Turbine Manufacturing Documentation F25

Molds

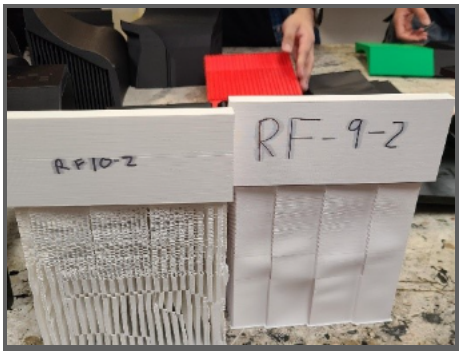
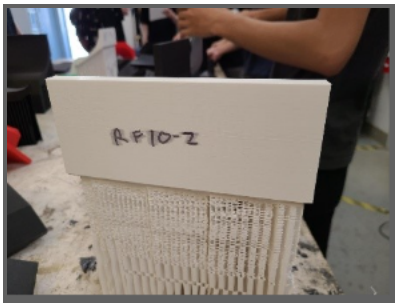
Some mold parts had their part numbers obscured by the supports. Make sure the numbers will be visible.

A part was mislabeled. Double check the numbers before sending it off to print.

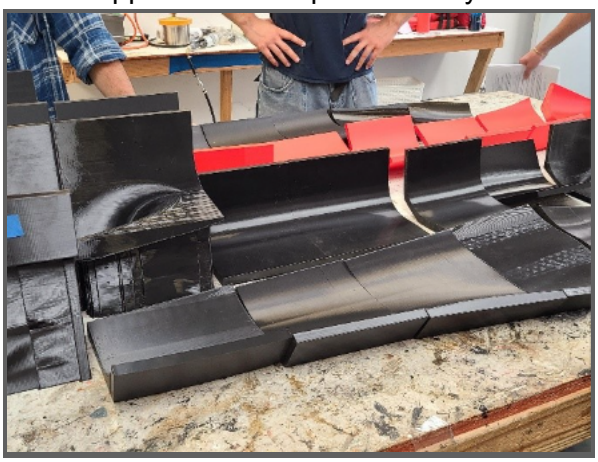
Need supports for front parts so they match with the back parts.

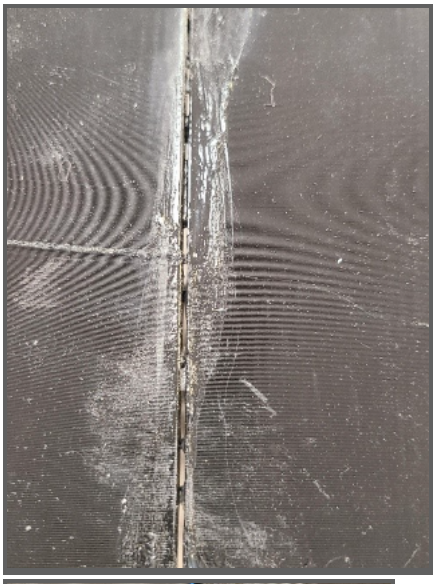
Gaps between mold parts. Fix by using body filler.

Crack on FL-9-1 and the supports are too long on each side. Cut off the sections interfering with other mold parts around it. Belt sander makes it hot and melts it together so the support is still strong

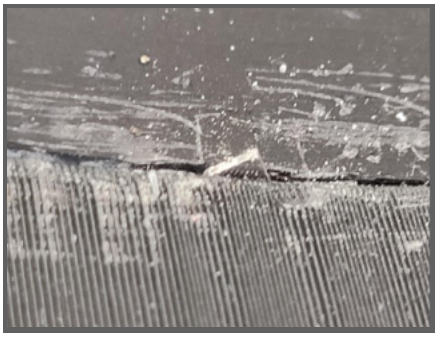
There was a long gap between FR-10-1&2 that needed to be filled with glue, but was difficult to do because of the mold set-up. We put glue on a piece of cardboard to get the glue in and deep into it without getting glue on the mold surface.

FL-2-2&3 need to be replaced. The surface broke.
